Addendum No. 003

Subject: 2020 Classroom Modernizations
SDP Contract Numbers: B-001 C of 19/20 & B-003 C of 19/20

Location: Francis Scott Key School
2230 S. 8th St, Philadelphia PA 19148

This Addendum, dated February 27, 2020, shall modify and become part of the Contract Documents for the work of this project. Any items not mentioned herein, or affected by, shall be performed strictly in accordance with the original documents.

1 KINDERGARTEN - ROOM 5
14.1 1/4" = 1'-0"

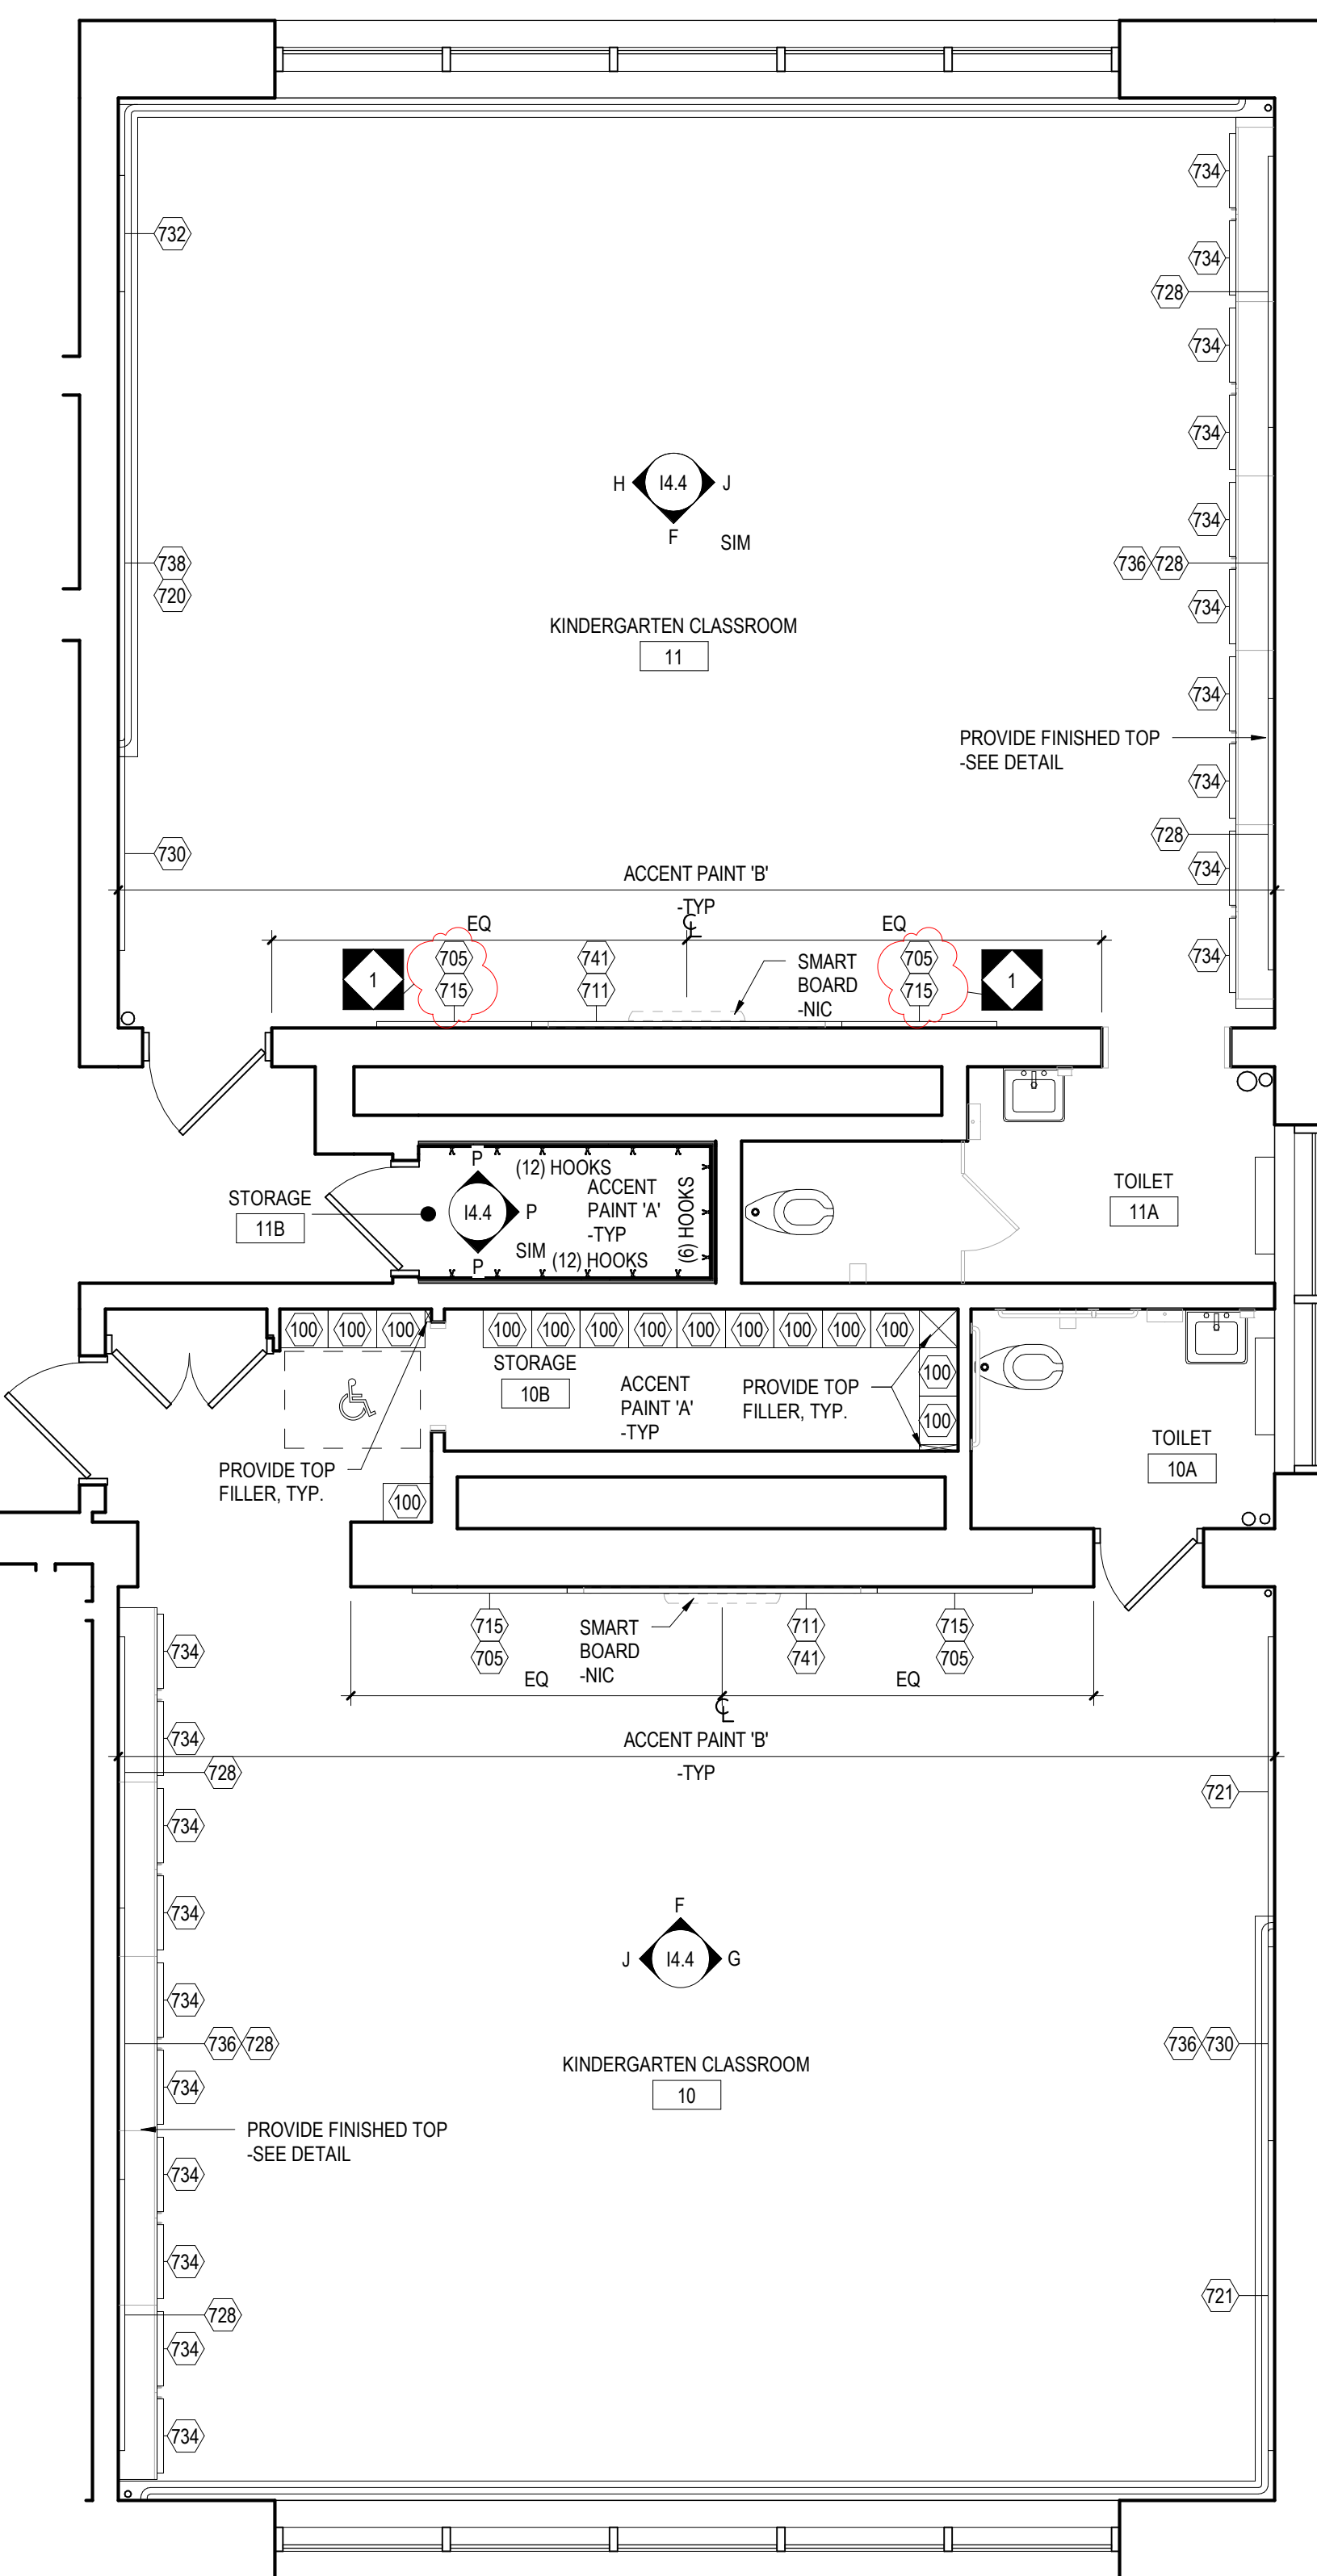
1. REVISE detail 1/I4.1 KINDERGARTEN – ROOM 5 – Revise "Tack Board w/ Aluminum Frame" from 712 to 713. Revise "Marker Board w/ Aluminum Frame" from 702 to 703.
2. REVISE detail 2/I4.1 KINDERGARTEN – ROOM 10 – Revise "Tack Board w/ Aluminum Frame" from 714 to 715. Revise "Marker Board w/ Aluminum Frame" from 704 to 705.

1 FIRST GRADE - ROOM 3 & 4
1/4" = 1'-0"

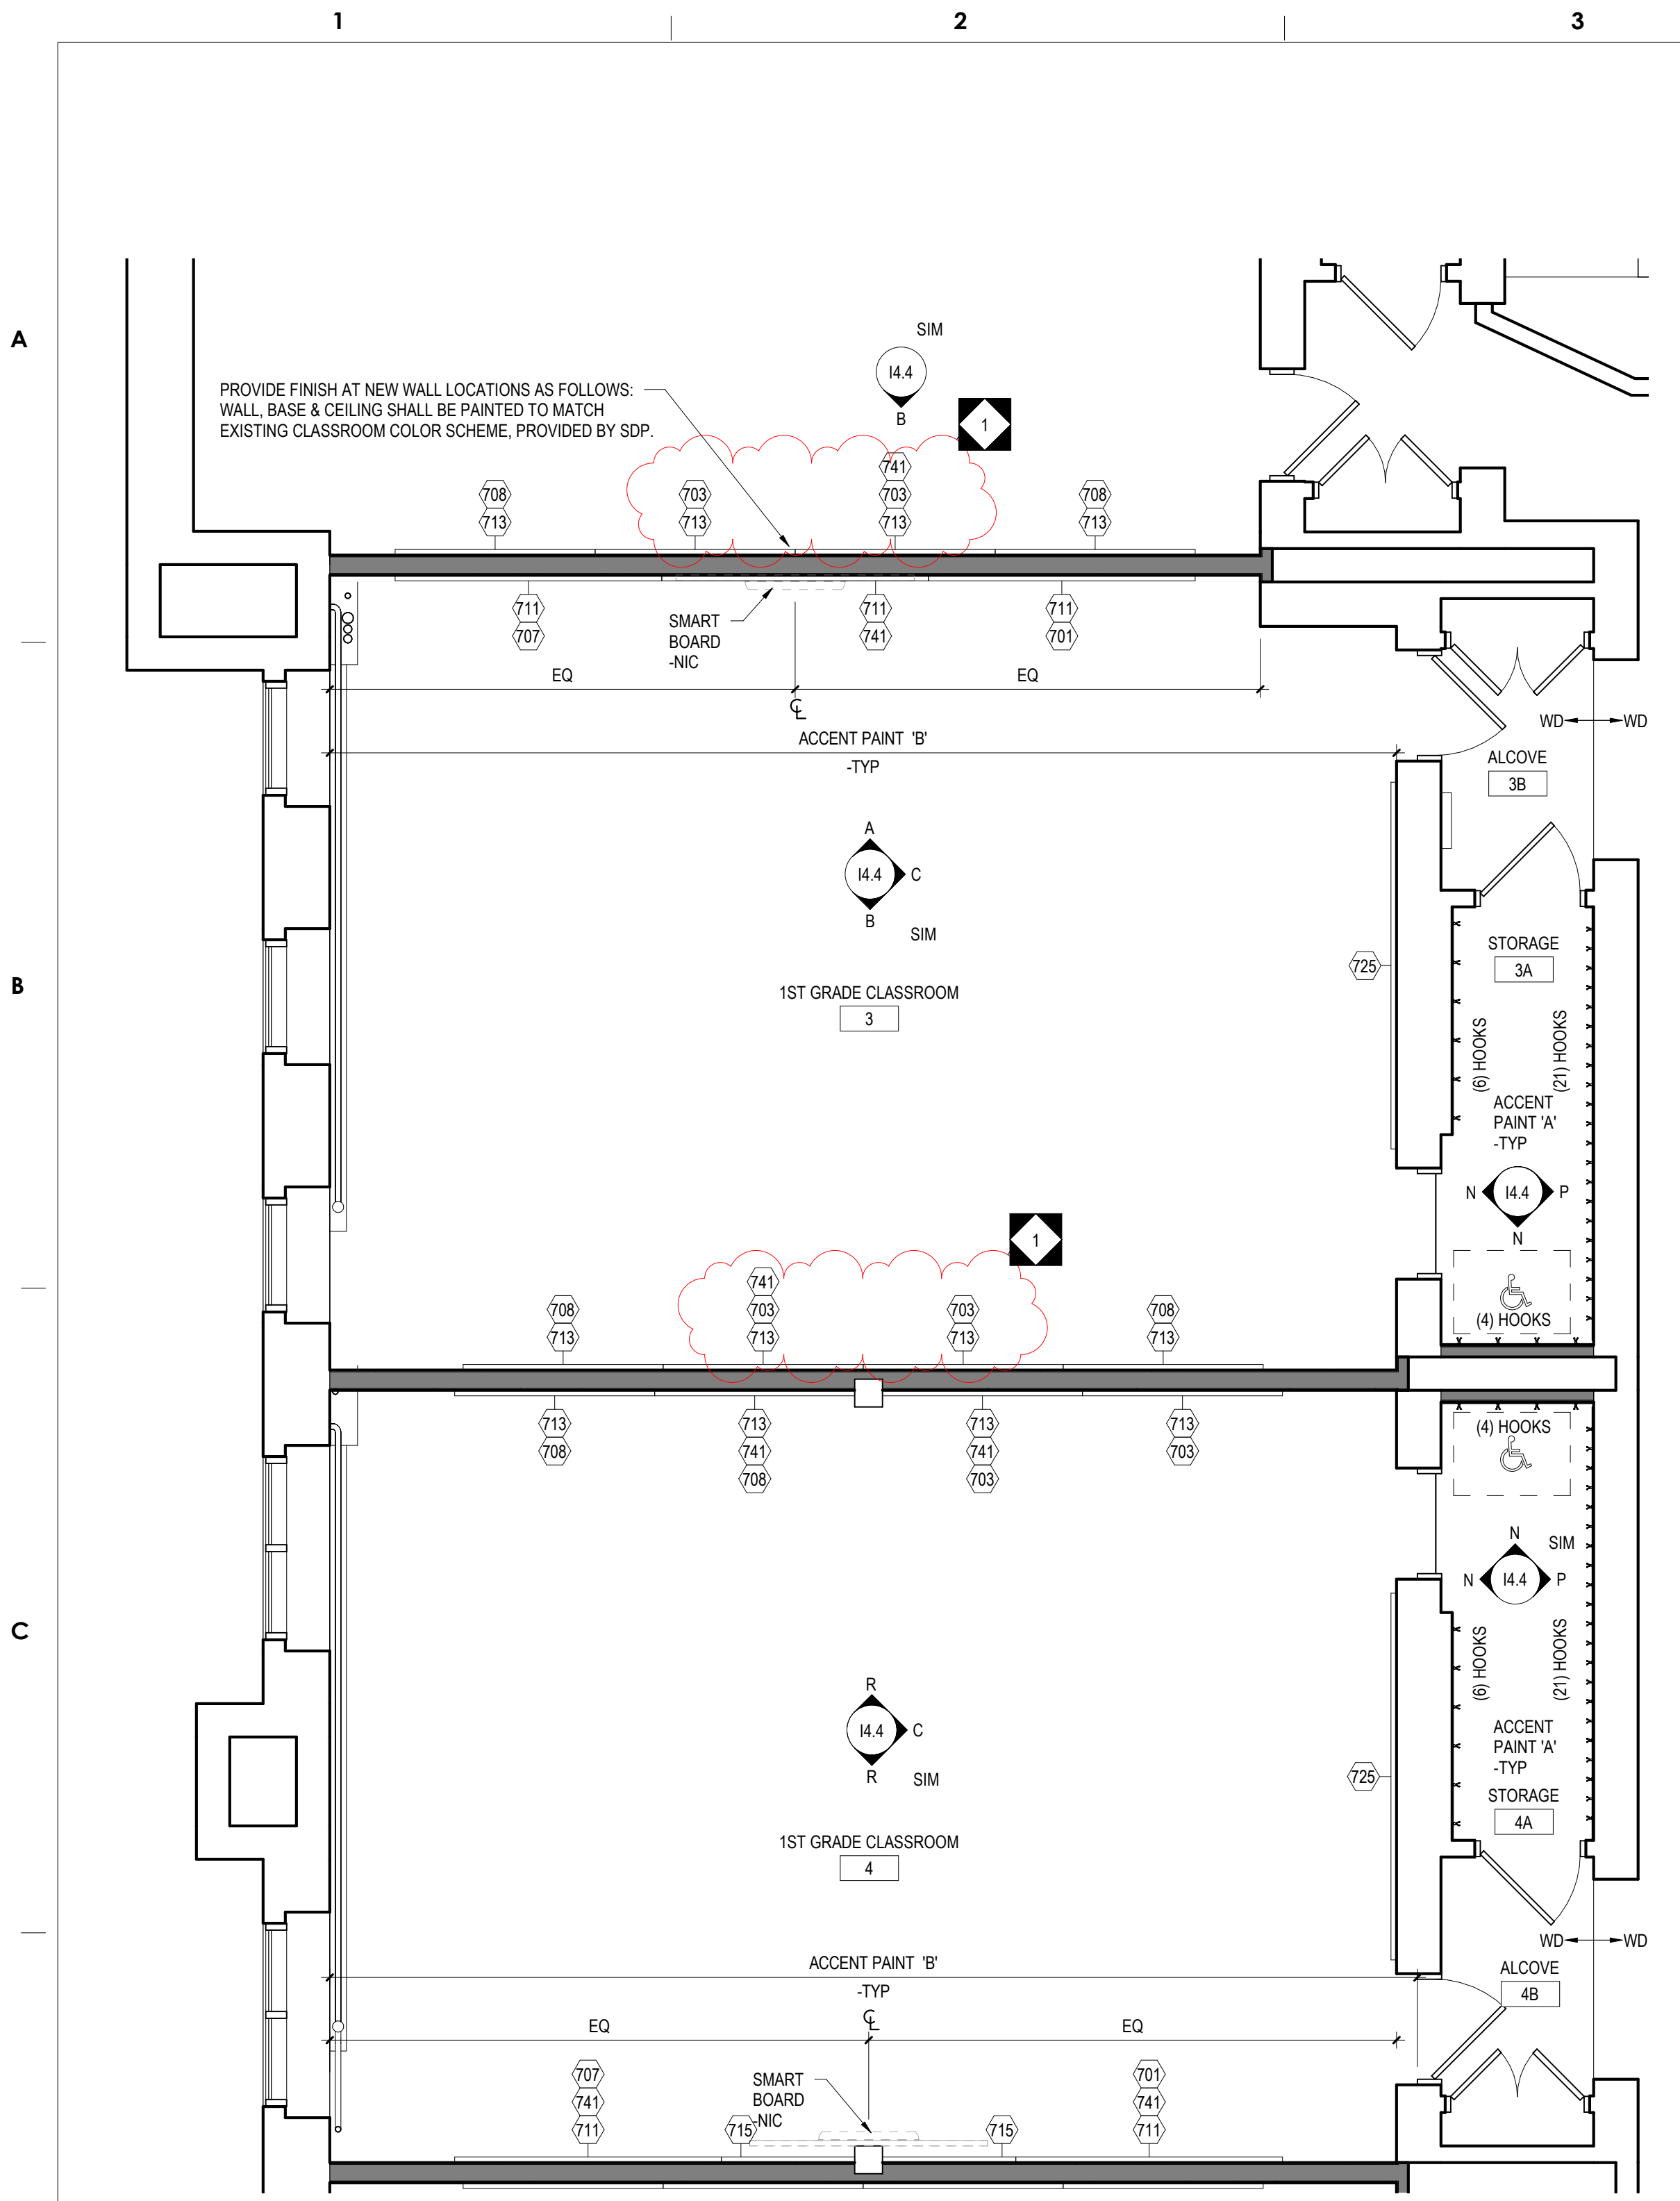
1. REVISE detail 1/I4.2 FIRST GRADE CLASSROOM – ROOM 3 & OPPOSING CLASSROOM WALL – Revise "Tack Board w/ Aluminum Frame" from 712 to 713. Revise "Marker Board w/ Aluminum Frame" from 702 to 703.
2. REVISE detail 2/I4.2 SECOND GRADE – ROOM 13 – Revise "Tack Board w/ Aluminum Frame" from 710 to 711.
3. REVISE detail 3/I4.2 SECOND GRADE CLASSROOM – ROOM 16 – Revise "Tack Board w/ Aluminum Frame" from 712 to 713. Revise "Marker Board w/ Aluminum Frame" from 702 to 703.
4. REVISE detail 4/I4.2 FIRST GRADE CLASSROOM – ROOM 12 – Revise Smart Board location to align with right side of Visual Display Infill.
5. REVISE detail 5/I4.2 SECOND GRADE – ROOM 18 – Revised one continuous "Frameless Marker Board Infill" from 716 into three separate markerboard/tack board infills

1 THIRD GRADE
14.3 1/4" = 1'-0"

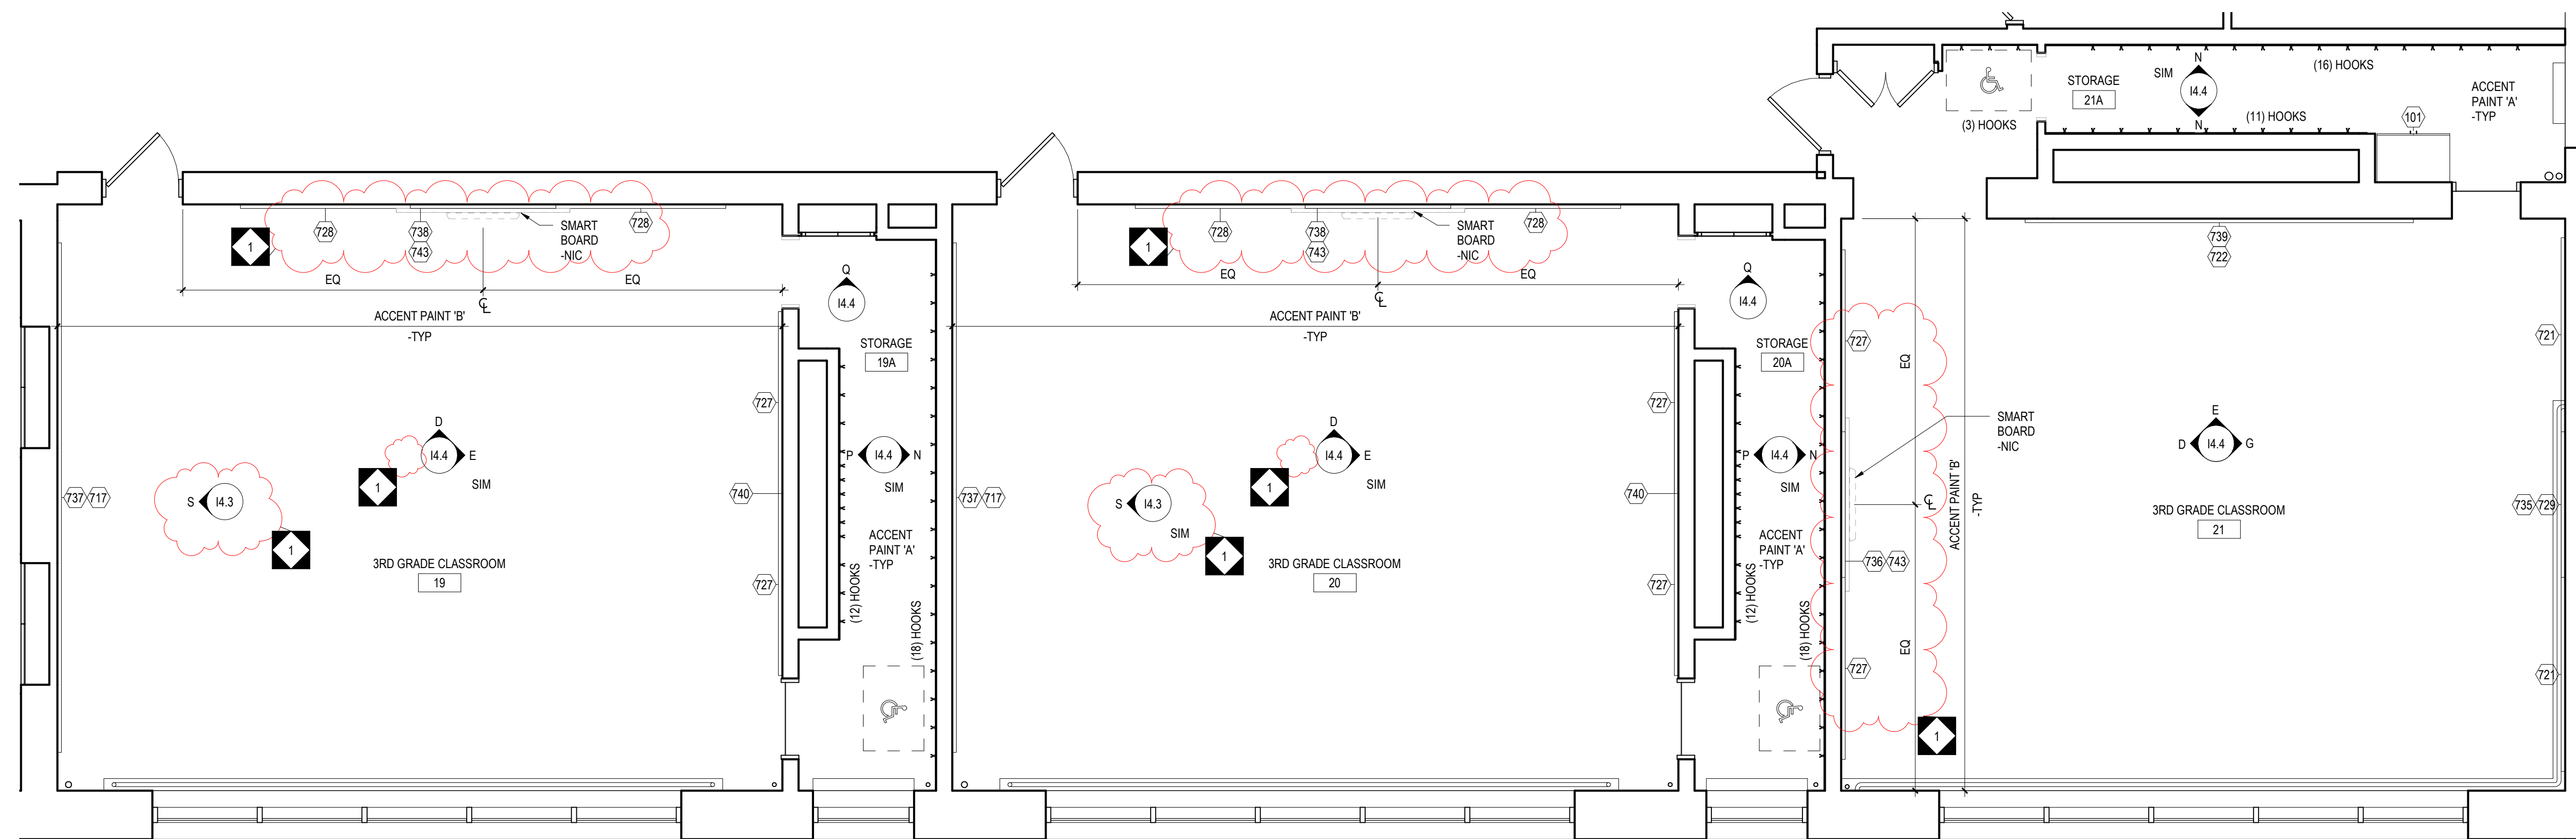
1. REVISE detail 1/I4.3 THIRD GRADE – ROOMS 19 and 20 – Revised one continuous "Frameless Marker Board Infill" from 718 into three separate markerboard/tack board infills as follows, "Frameless Markerboard 743, centered. Provided "Frameless Tack Board" 728 on either side.
2. REVISE detail 1/I4.3 THIRD GRADE – ROOM 21 – Revised one continuous "Frameless Marker Board Infill" from 717 into three separate markerboard/tack board infills as follows, "Frameless Markerboard 743, centered. Provided "Frameless Tack Board" 727 on either side.
3. ADD detail S/I4.3 "THIRD GRADE SECONDARY TEACHING WALL – TYPICAL" elevation to sheet to correspond to owner visual display changes. Revised this elevation indicator on detail 1/I4.3 THIRD GRADE in classrooms 19 and 20.
4. ADD "743 FRAMELESS MARKERBOARD INFILL" to I4.3 – GENERAL CASEWORK AND EQUIPMENT SCHEDULE.

B SECONDARY TEACHING WALL 'A' - TYPICAL
1/4" = 1'-0"

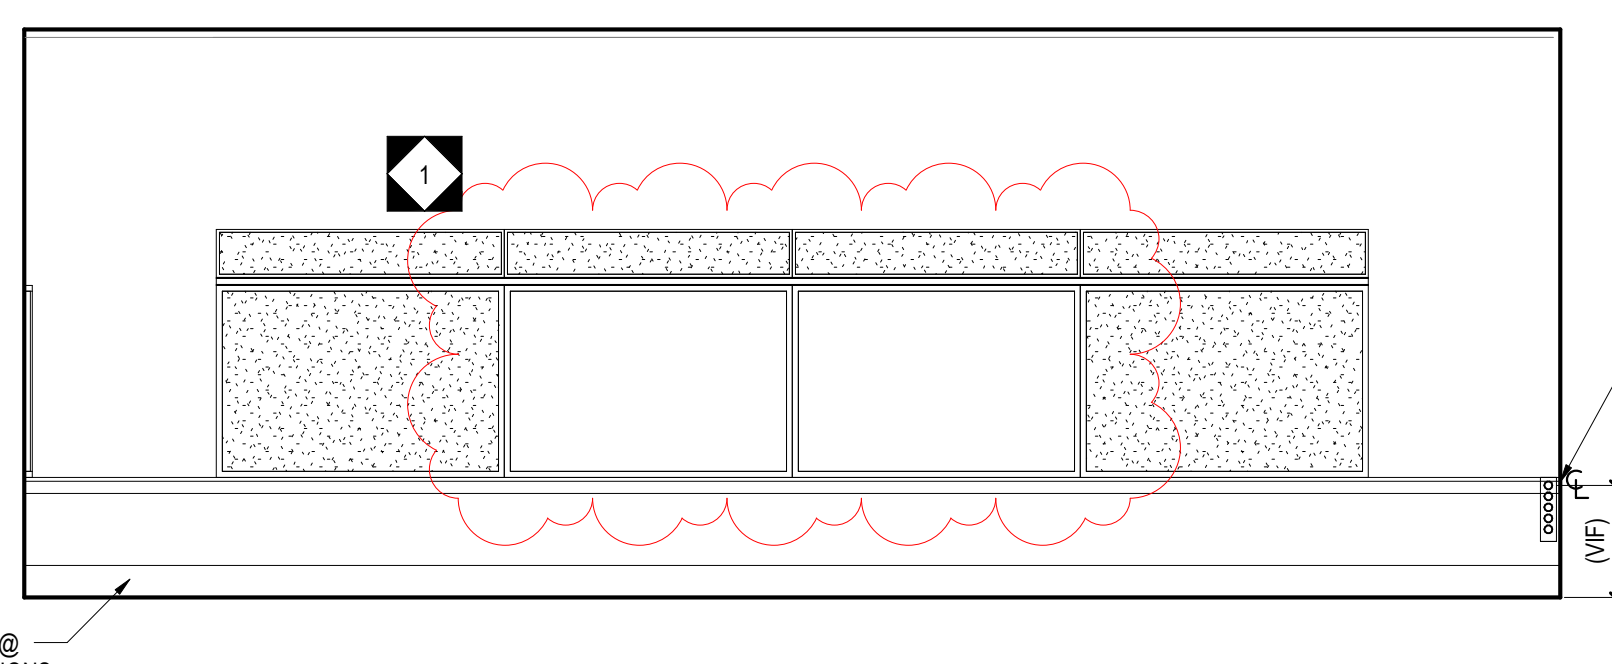
1. REVISE detail B/I4.4 SECONDARY TEACHING WALL 'A' – TYPICAL – Revise to show board size adjustment per the floor plans. Contractor shall reference the note and floor plans for actual sizing of boards, typical.
2. REVISE detail D/I4.4 PRIMARY TEACHING WALL 'B' – TYPICAL – Revise to show board size adjustment per the floor plans. Contractor shall reference the note and floor plans for actual sizing of boards, typical.
